REFERENCE: C.N.313.1990.TREATIES-2 (Depositary Notification)

CUSTOMS CONVENTION ON THE INTERNATIONAL TRANSPORT
 OF GOODS UNDER COVER OF TIR CARNETS (TIR CONVENTION)
 CONCLUDED AT GENEVA ON 14 NOVEMBER 1975

PROPOSED AMENDMENT TO ANNEX 6 OF THE CONVENTION

AMENDMENT TO THE TIR CONVENTION, 1975

Sketch No. 5

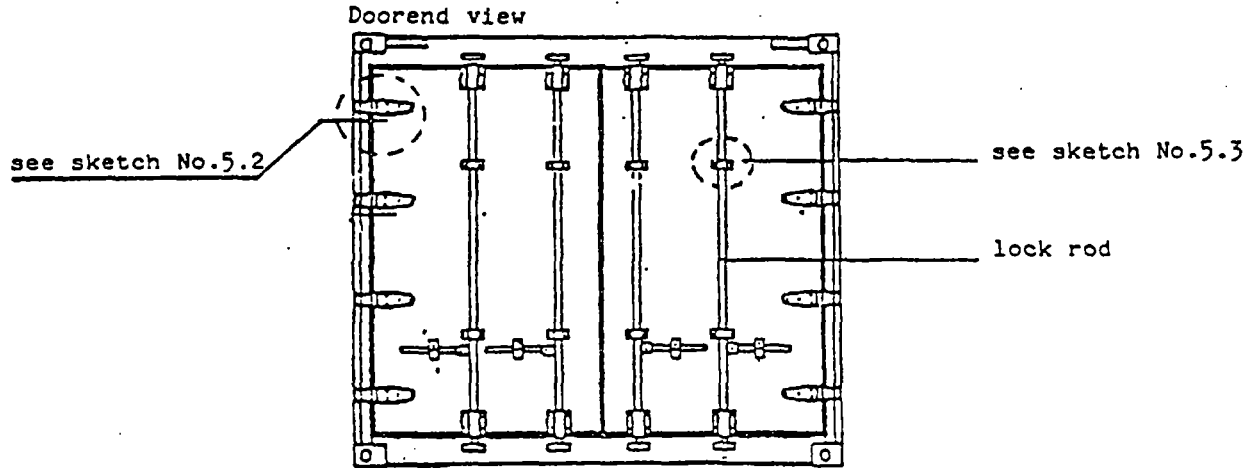
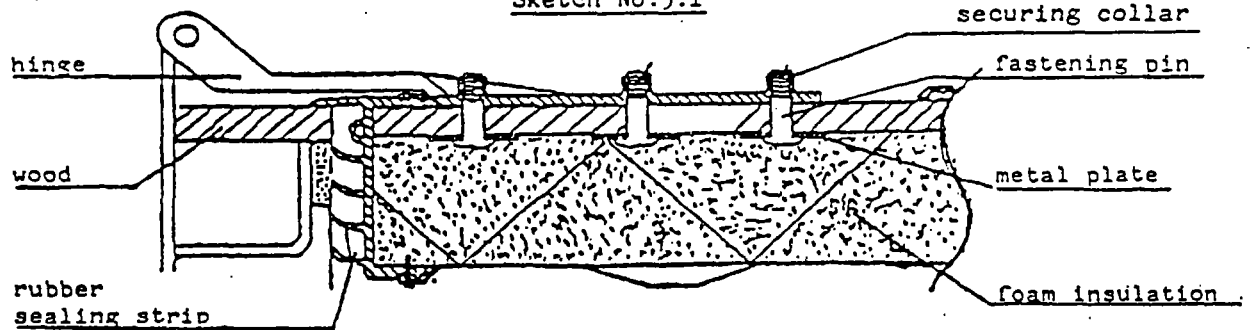
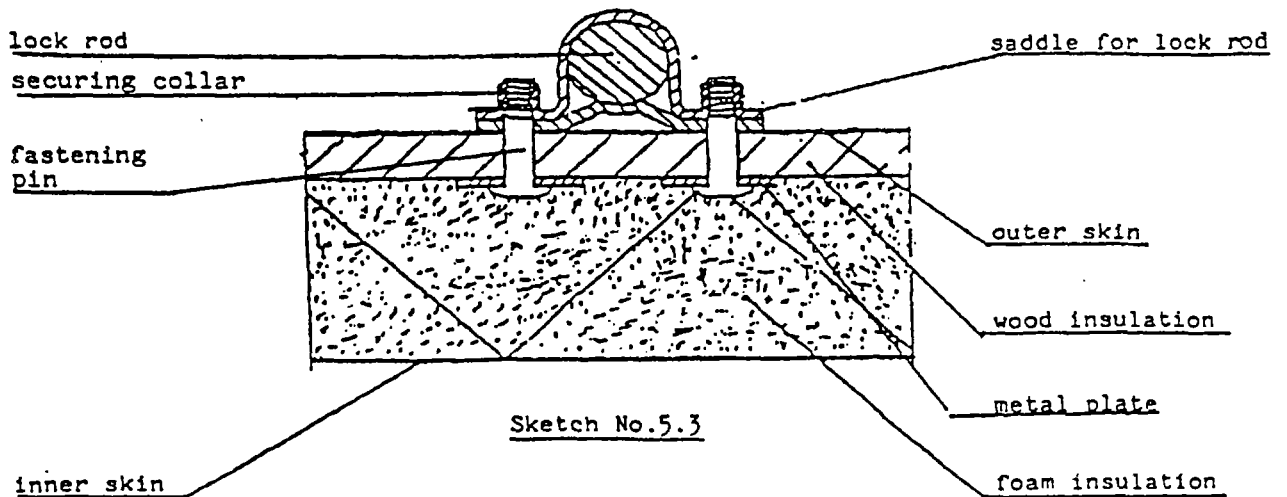
- (ii) A fastening device which is inserted from the inside of the insulated door construction on condition that:

the fastening pin and securing collar of the device are assembled by pneumatic or hydraulic tooling and fixed behind a plate or similar device fitted between the outer layer of the door structure and the insulation; and

the head of the fastening pin is not accessible from the inside of the load compartment; and

a sufficient number of securing collars and fastening pins are welded together and the devices cannot be removed without leaving visible signs of tampering (see sketch No.5 appended to this annex).

Croquis No 5

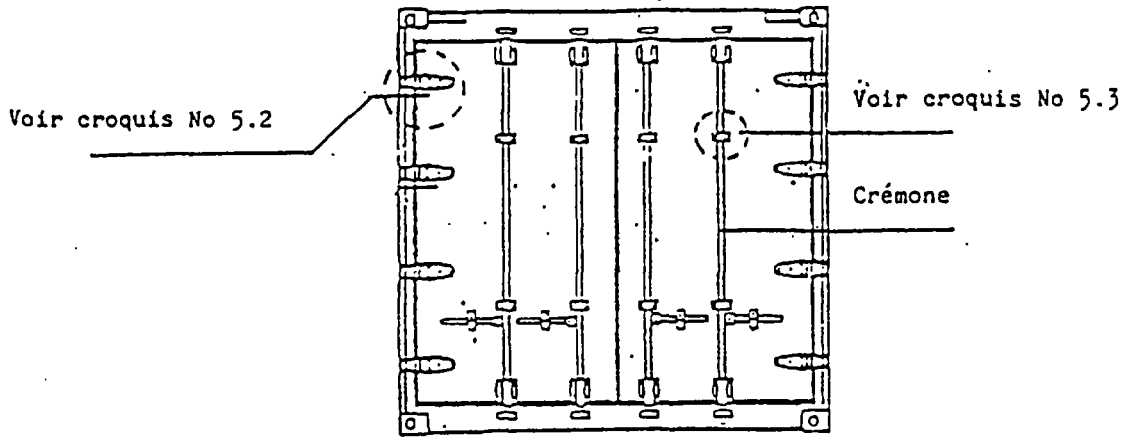
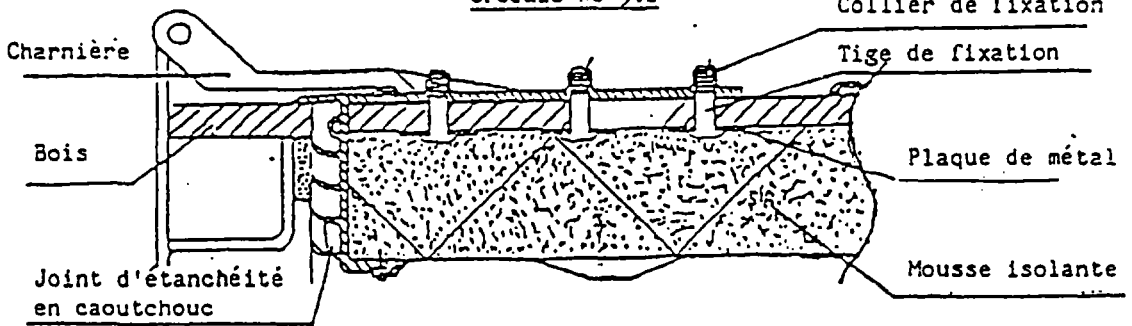
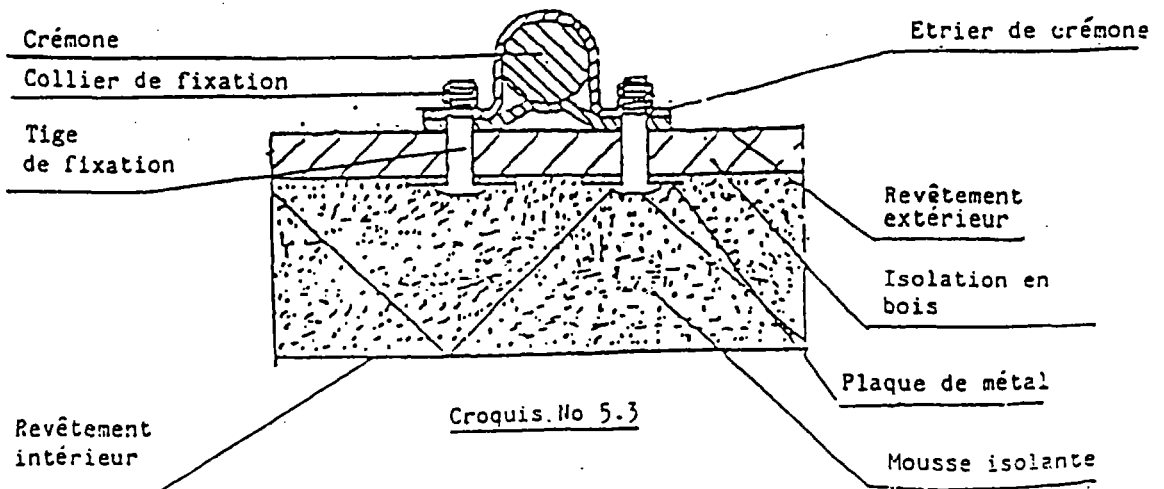
- ii) Un dispositif de fixation introduit de l'intérieur de la porte isolée, sous réserve :

que la tige de fixation et le collier de blocage du dispositif soient assemblés au moyen d'un outillage pneumatique ou hydraulique et soient fixés derrière une plaque ou un dispositif analogue inséré entre le revêtement extérieur de la porte et l'isolant; et

que la tête de la tige de fixation ne soit pas accessible de l'intérieur du compartiment réservé au chargement; et

qu'un nombre suffisant de colliers de blocage et de tiges de fixation soient soudés ensemble et qu'il ne soit pas possible d'enlever les dispositifs sans laisser de traces visibles (voir croquis No 5 joint à la présente annexe).

Рис. № 5

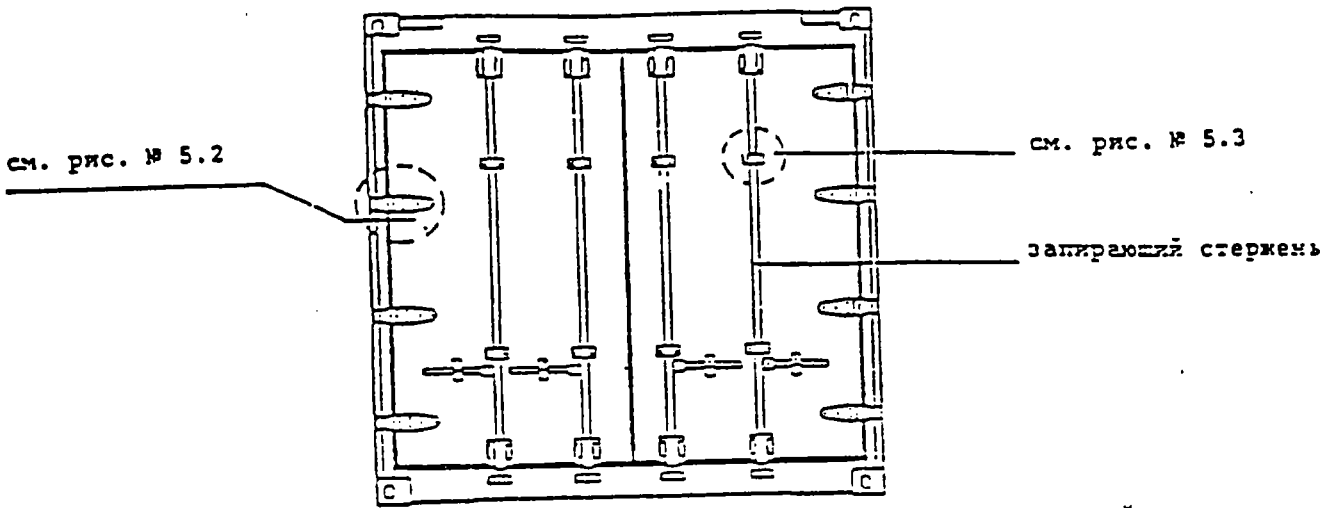
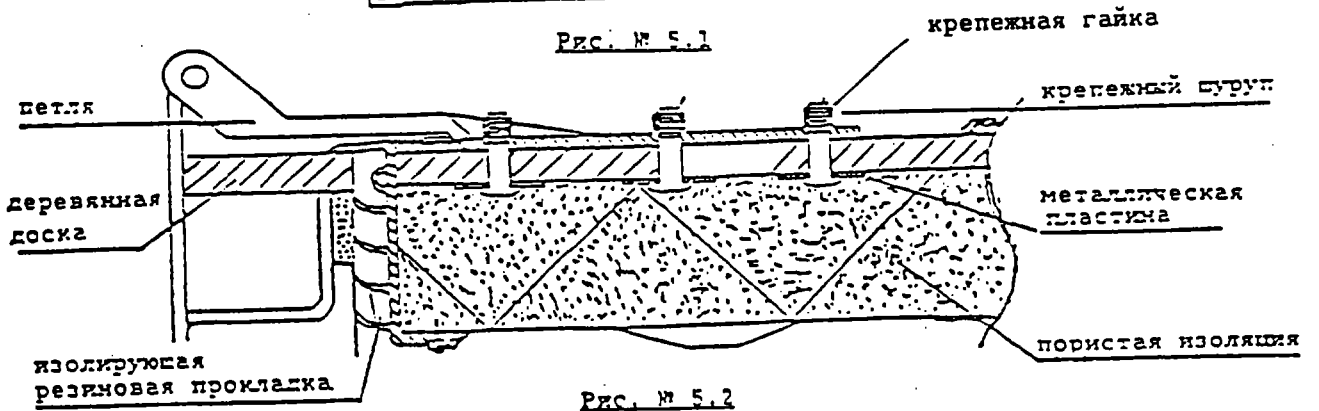
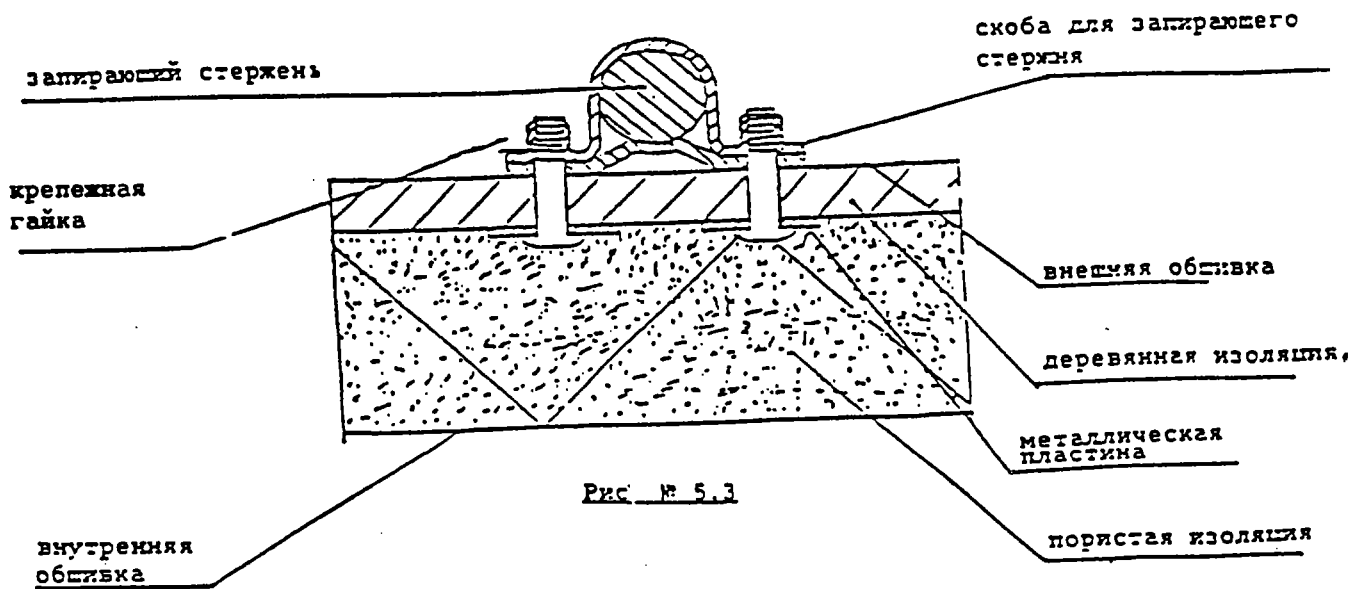
ii) крепежного приспособления, которое вставляется с внутренней стороны двери изотермической конструкции при условии, что:

крепежный болт и крепежная гайка приспособления соединены при помощи пневматических или гидравлических инструментов и крепятся с обратной стороны пластины или подобного приспособления, установленного между наружным слоем конструкции двери и изоляцией;

не имеется доступа к головке крепежного болта изнутри грузового отделения; и

достаточное количество крепежных гаек и крепежных болтов соединено при помощи сварки, и приспособления невозможно удалить без оставления видимых следов (см. рис. № 5 к настоящему приложению).
